Modification to run CPU09CMI on 4MHz bus.

9001-11641

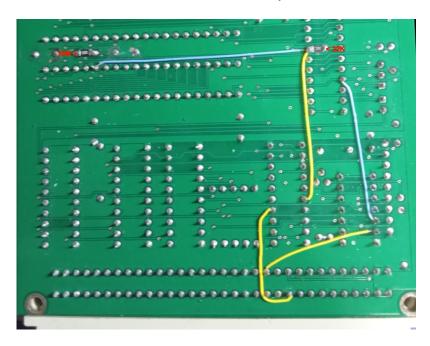
Replace xtal into 16MHz.
Replace C1 and C2 by 15pF.
Place 10M smd between crystal pins.
Replace GAL CMI_1 by CMI-4_1
Only use the HD63C09.

Cut trace between U4-14 and J1 C-21 (B_VMA-) For REV:0.9 print only cut trace from J1 A23 to R15

Cut trace between U13-19 and via (OVMA-) Place 22K resistor between U13-19 and Gnd Place wire from U6-35 to U13-19 (blue) and U4-6 (Q) (yellow) Place wire from U4-14 to J1 A-23 (B_Q) (yellow)

Place wire from U3-7 to J1 C-21 (B_VMA-), Or: To keep CPU09CMI 68x02 compatible or need VMA- signal with 68x02 on the bus for CPU09GPP or CPU09RAM card.

Cut trace between U3-4 and U3-5

Place wire from U3-5 to U13-9 (VMA) (blue) Place wire from U3-6 to J1 C-21 (B_VMA-) (yellow)
